NYN-88007

January 22, 1988

Subject: Proposed Modification to Control Building HVAC (CBA) System

CONTROL ROOM HABITABILITY SYSTEM DESCRIPTION

FIGURE 2

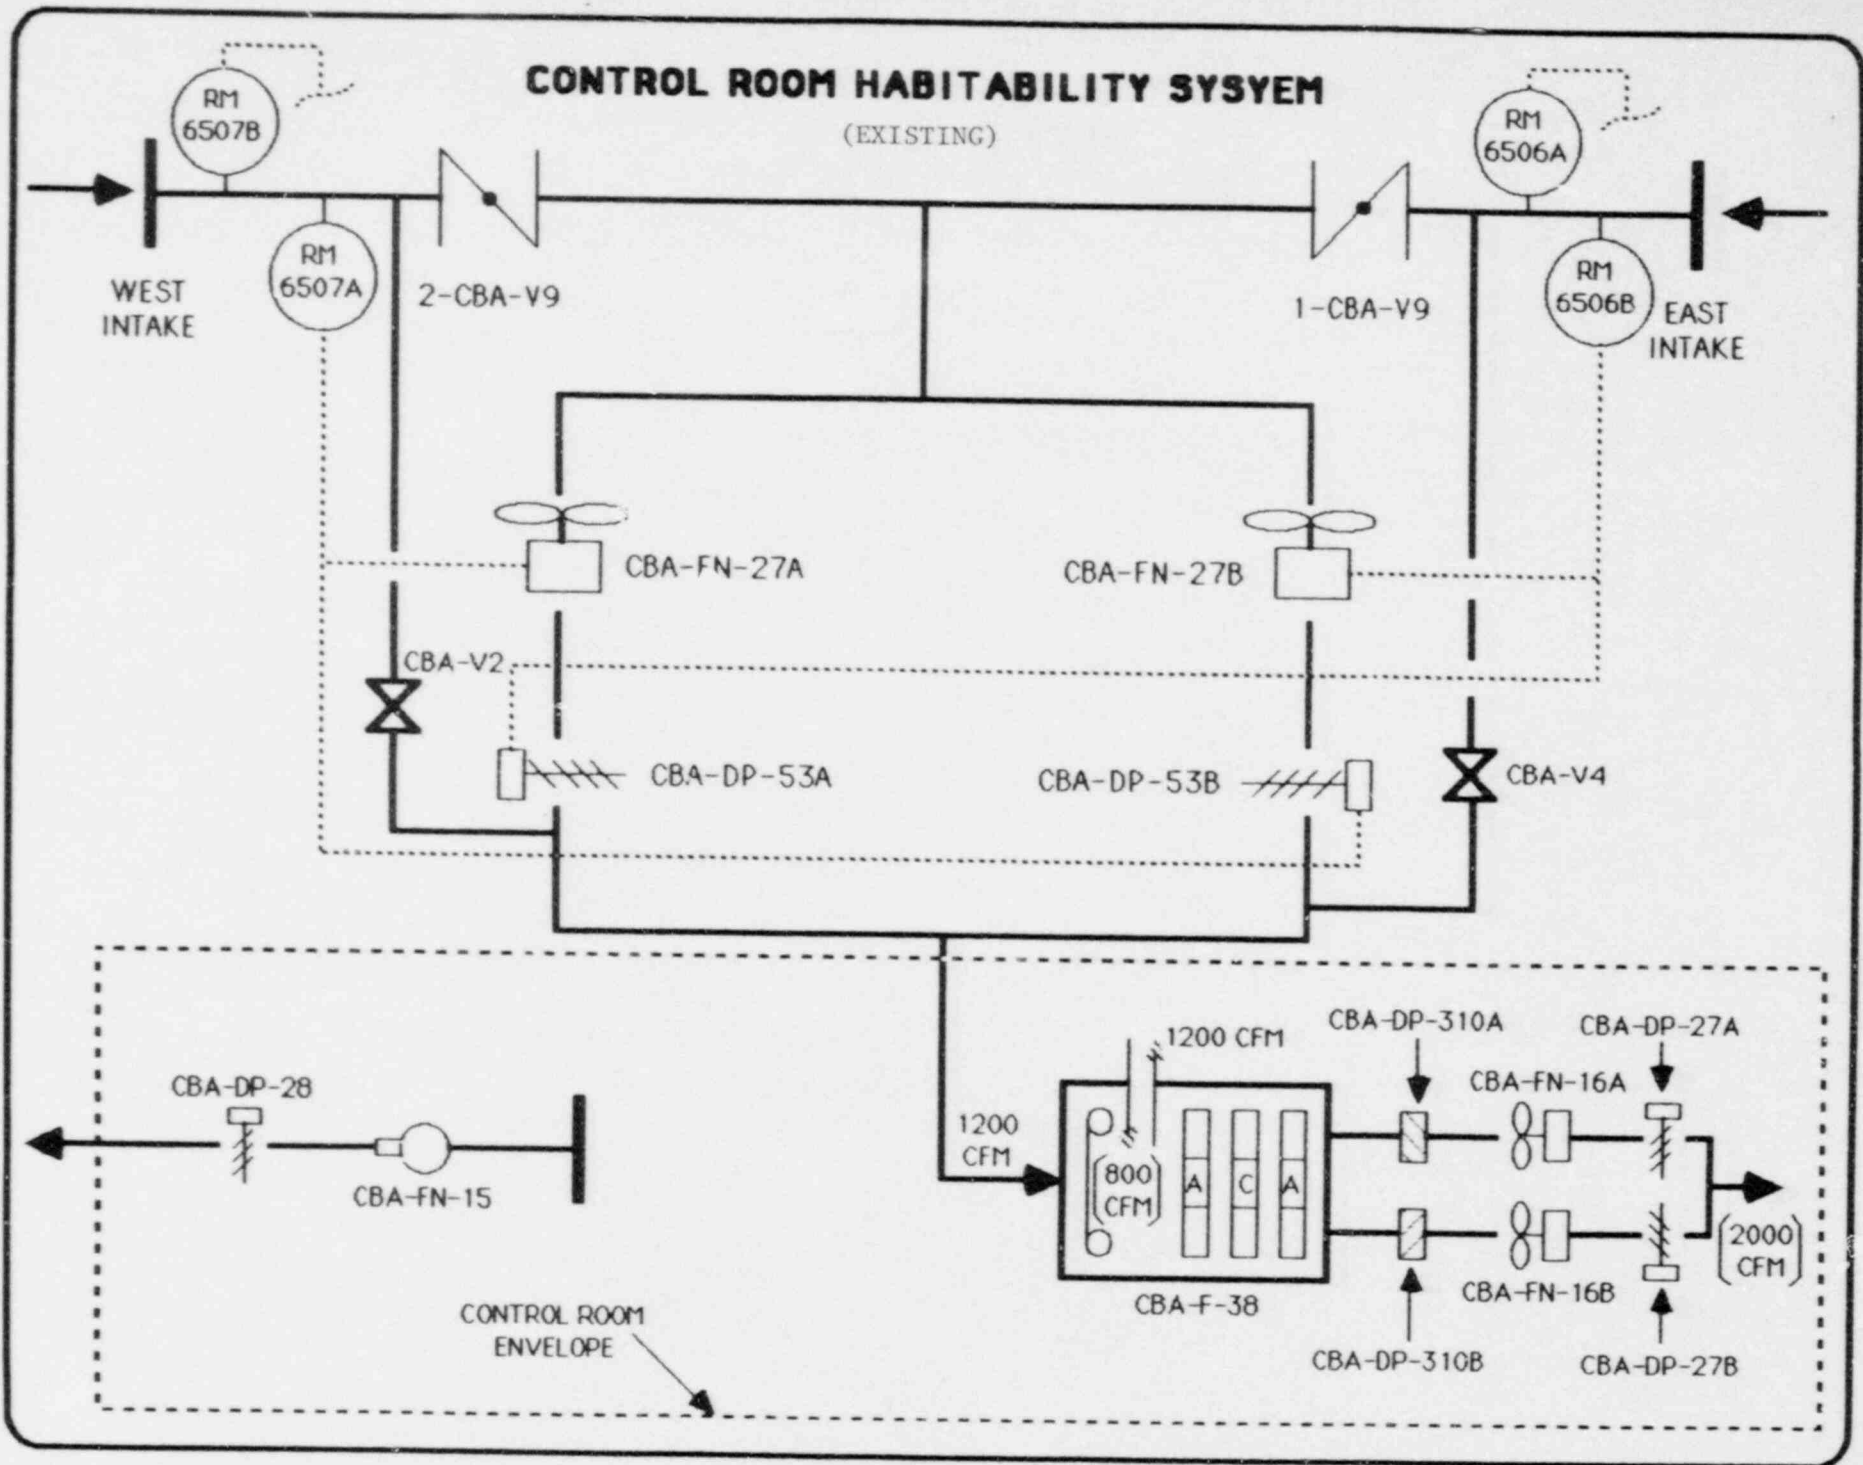
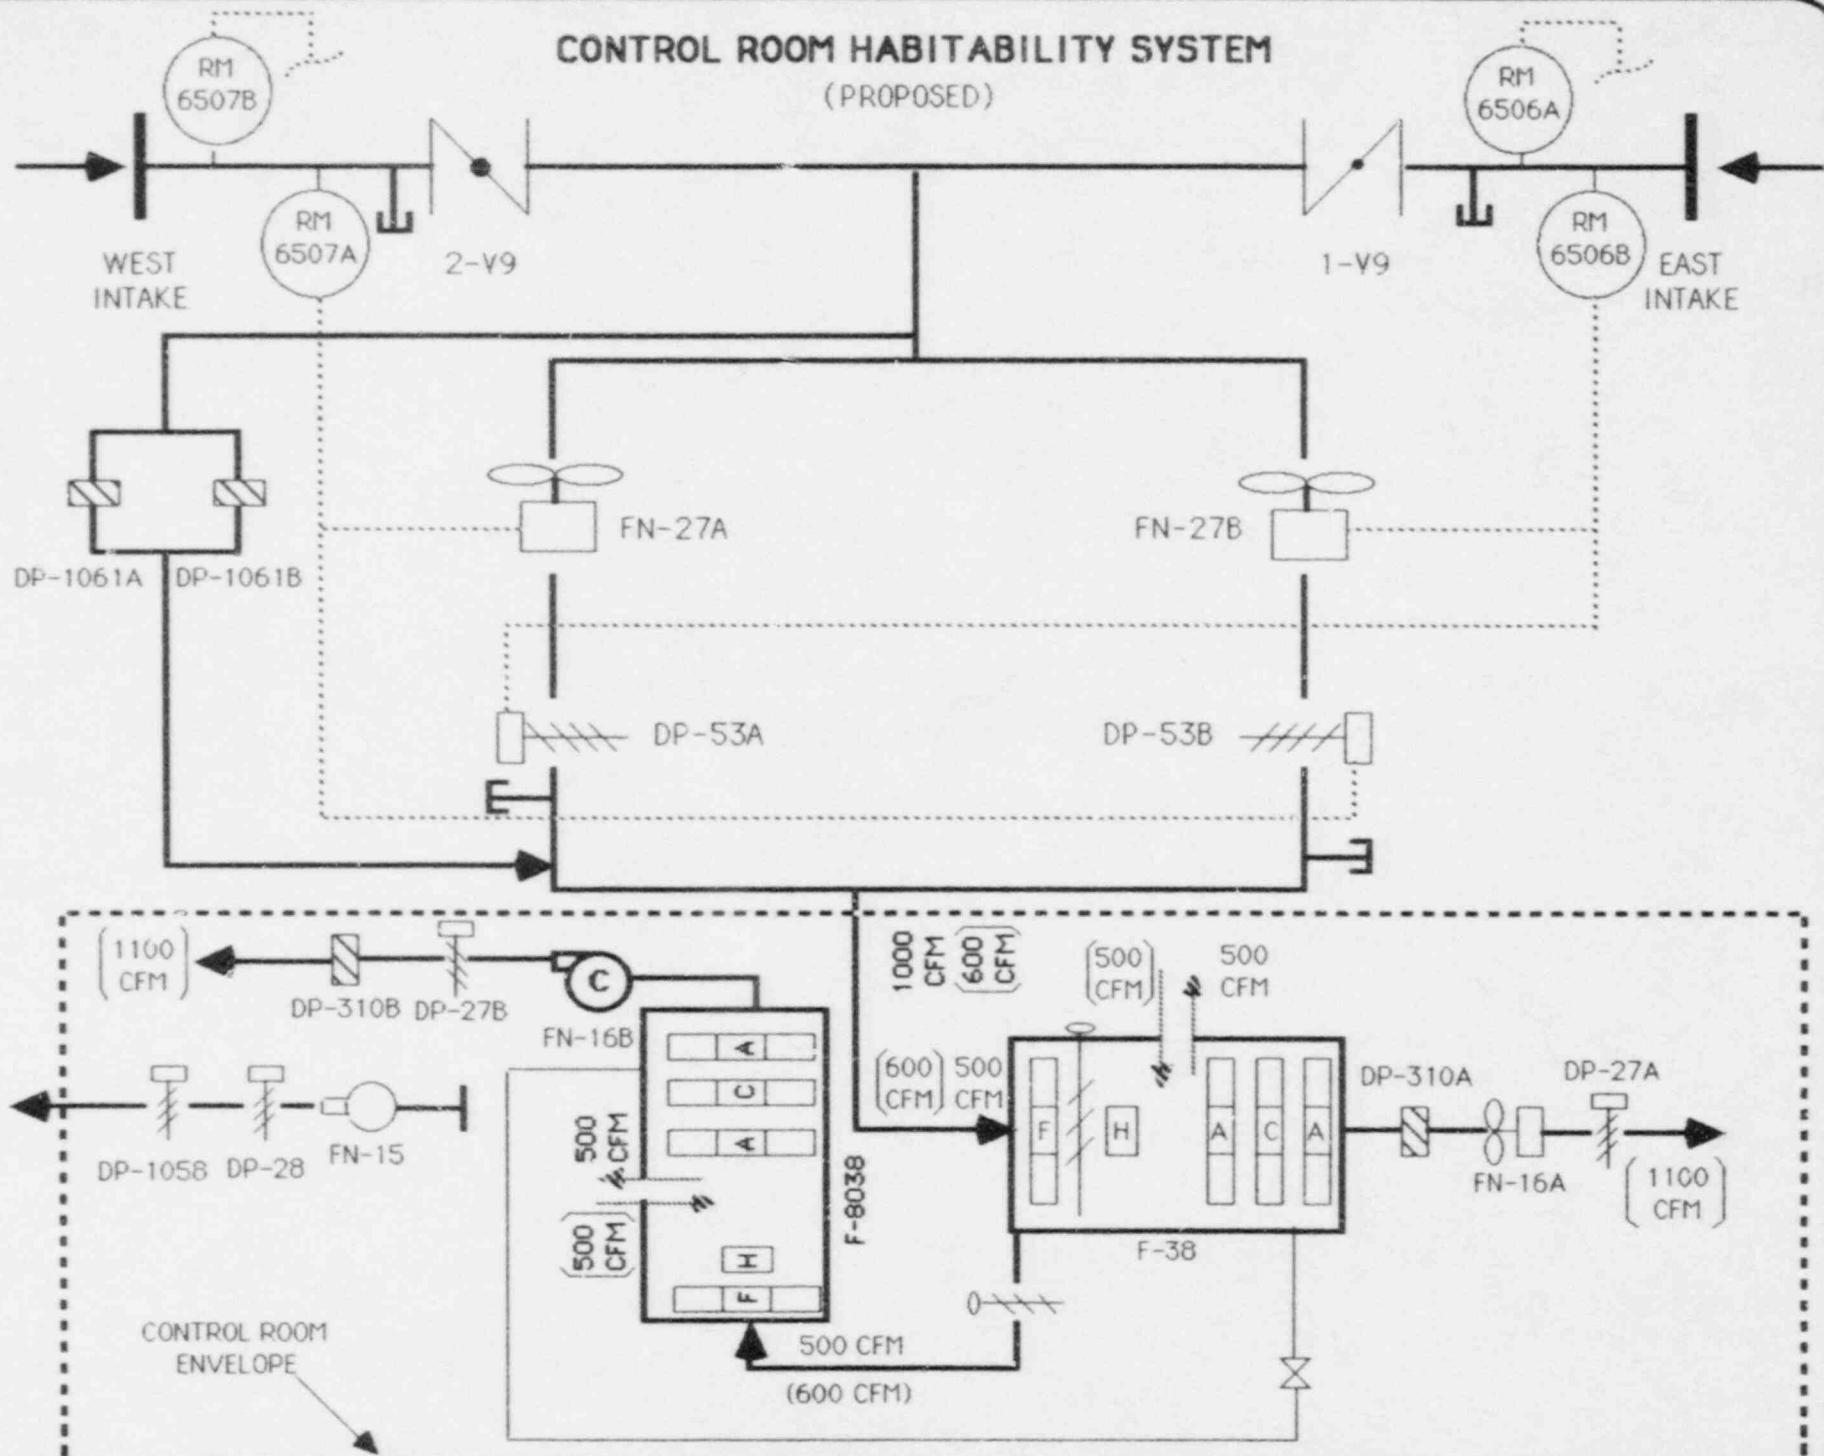
One of the specific functions of the Control Building HVAC (CBA) System is to maintain the radiological exposure to Station operators within allowable limits for a 30-day mitigation period following a Design Basis Accident (DBA). These limits are specified in References 1 and 2(a). The subsystems of the CBA System which limit radiation exposure will collectively be referred to herein as the Control Room Habitability System. References 3 and 5 provided a description of those subsystems, as currently designed, which perform this function. Figure 1 shows the existing system configuration.

Modifications to the CBA System are proposed to be implemented prior to operation above 5% of rated power (References 3 & 4). The configuration of the modified Control Room Habitability System is shown in Figure 2 and consists of the following subsystems:

The emergency makeup air is drawn from the intakes via piping and back-draft dampers (CBA-DP-1061A, 1061B) which bypass the normal makeup air fans and discharge dampers. This makeup air enters a suction plenum immediately upstream of CBA-F-38 which is made common to CBA-F-8038 by connecting ductwork. The makeup air is drawn through either or both filter units. Each unit is designed with a prefilter, an electric heater for humidity control, and a HEPA-carbon-HEPA filter configuration. Each filter housing is also designed with an orifice, immediately downstream of the heater, for recirculation airflow. The mixture of makeup air and recirculation air is drawn through the HEPA-carbon-HEPA configuration and discharged into the Control Room HVAC Equipment Room. The filtered air is then distributed throughout the Control Room complex via the Control Room Air Conditioning System.

A 4-inch diameter pipe with a manual isolation valve is provided to cross-connect the two filter units at a point downstream of the carbon adsorber sections. The isolation valve will be throttled to a pre-set normally open position. During single train operation, this alignment will provide approximately 50 cfm of air flow through the carbon
